**CITY OF RAYMORE**

**ADDENDUM NO. 1**

T.B. Hanna Station House Reno  
Project #19-276-204

**Addendum No. 1 - Clarification.**

2 Roof Plan  
1/4" = 1'-0"

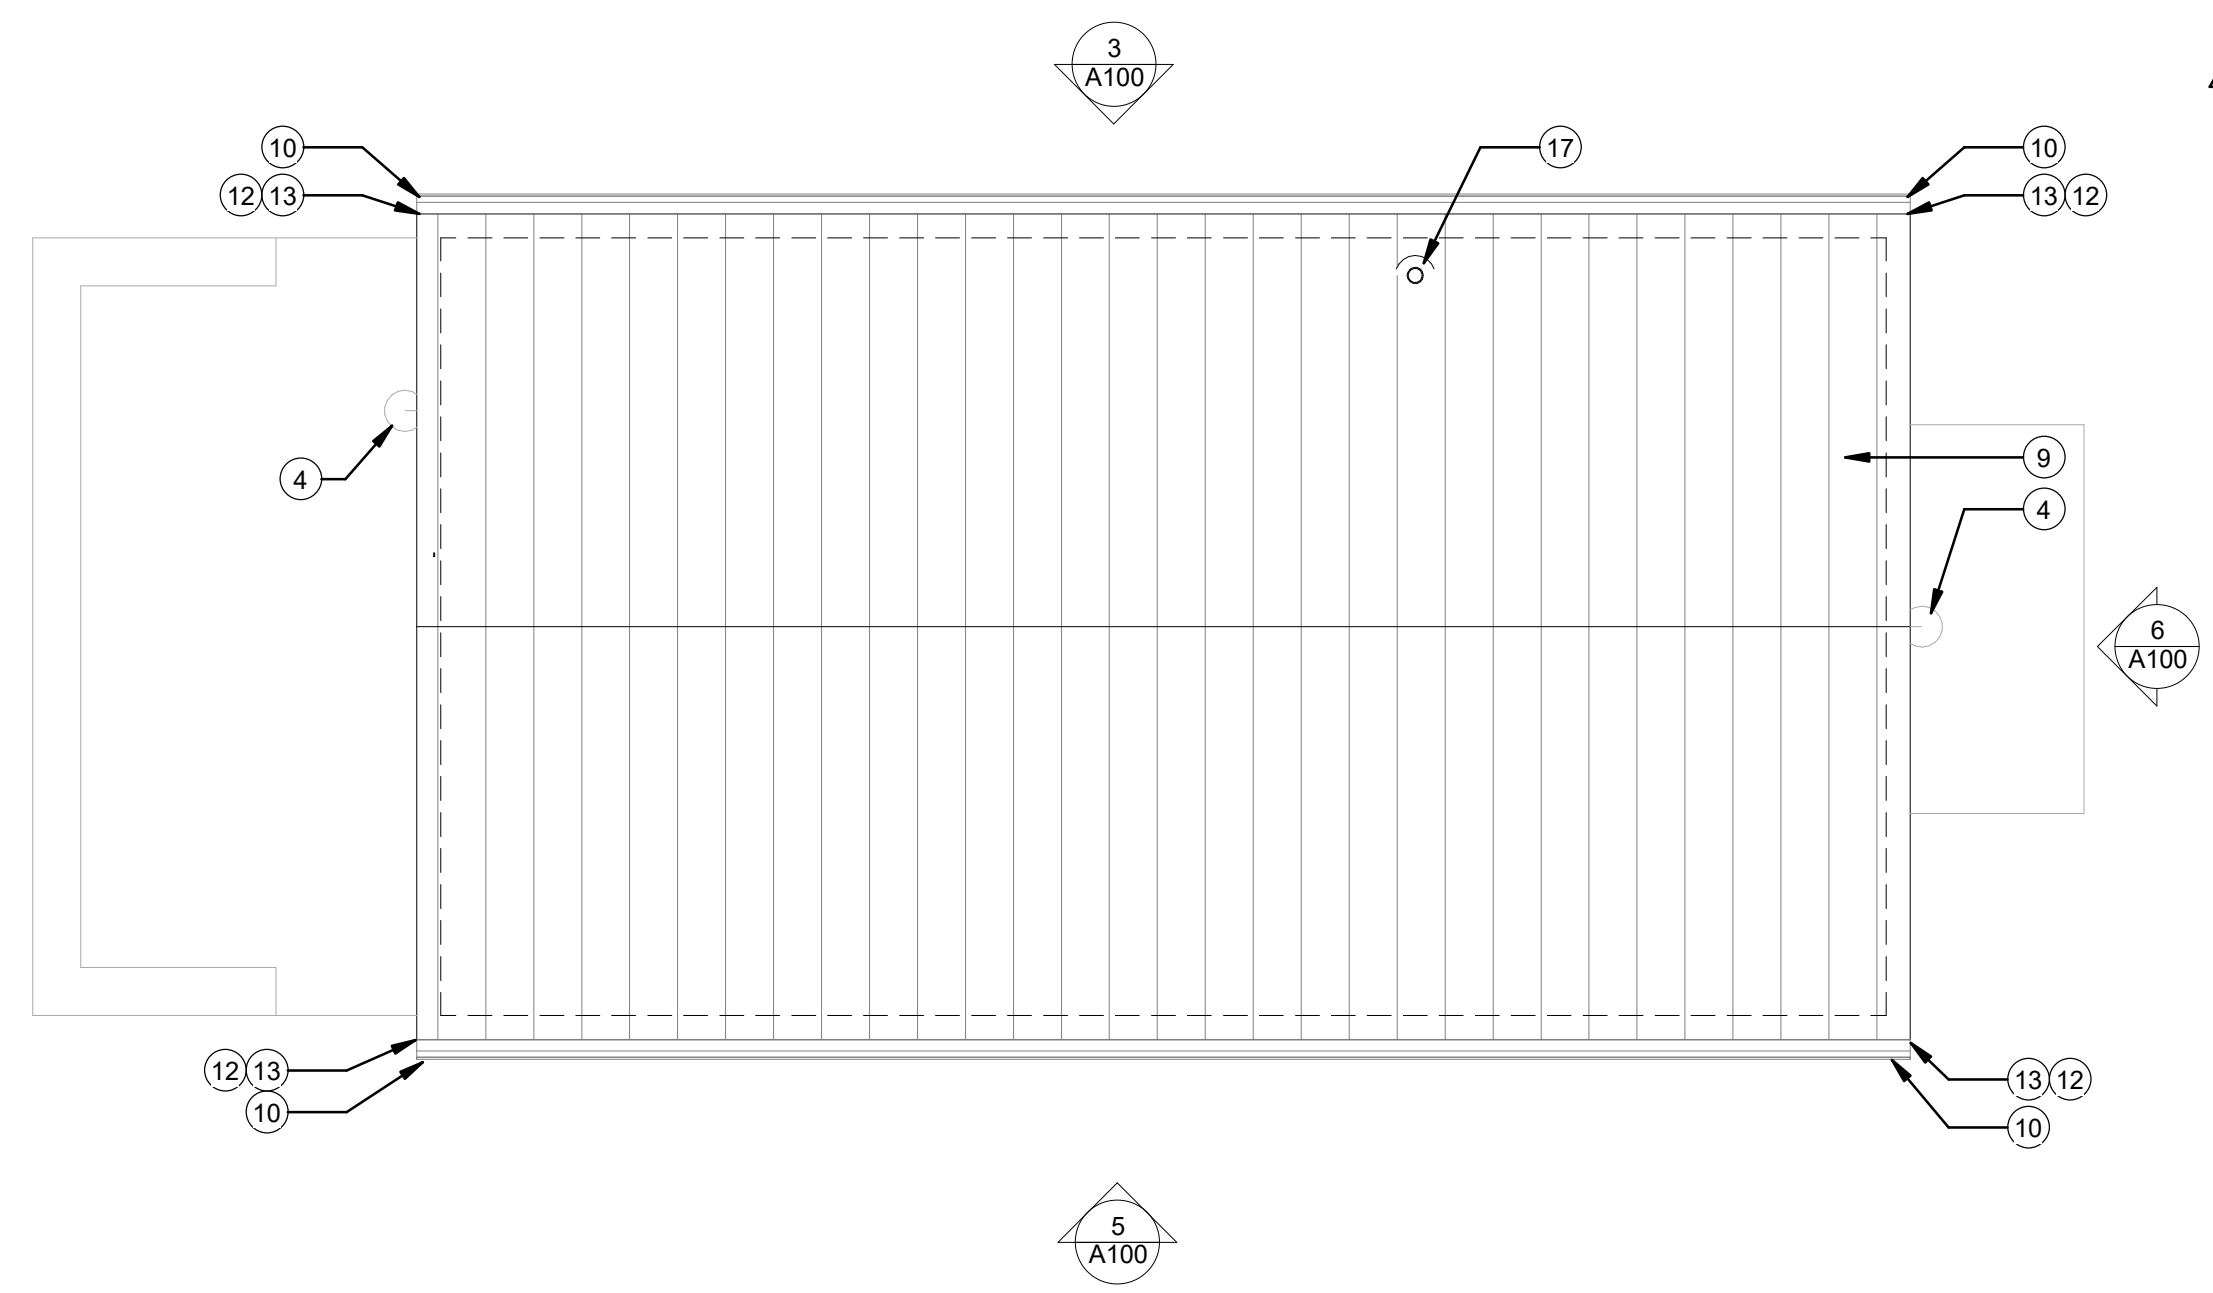
1. (Revised) Occupancy Type is S2.  
(Revised) G00 - Project Overview – Delete 'STAINING EXTERIOR DECK'  
(Revised) D100 – Note 14 – EXISTING DECK – NO WORK  
(Revised) A100 – Note 11 – EXISTING DECK – NO WORK
2. (Revised) D100 – Note 7
3. (Revised) D100 – Note 23
4. (Revised) A100 – Note 3
5. (Revised) A100 – Note 4
6. (Revised) A100 – Note 15
7. (Revised) A100 – Note 16
8. (Revised) A100 – Note 18
9. (Revised) A100 – Note 20
10. (ADD) S100 – Note 9 – INSTALL SIMPSON SDWC SCREWS BETWEEN ALL ROOF FRAMING MEMBERS (RAFTERS TO TOP PLATE AND RAFTERS TO BEAM).
11. (ADD) S100 – PROVIDE FULL SISTER OR REPLACEMENT OF DAMAGED RAFTER, IN KIND.
12. (ADD) Sheets PE001, PE002, PE100

- INSTALL NEW 4" K-STYLE GUTTER AND DOWNSPOUTS ALONG THE NORTH AND SOUTH SIDES OF THE ROOF. PROVIDE ALL REQUIRED GUTTER HANGERS, END CAPS, DOWNSPOUT ELBOWS AND ANY OTHER REQUIRED ACCESSORIES FOR COMPLETE INSTALLATION. SLOPE GUTTERS TO DRAIN EXISTING DECK. NO WORK.
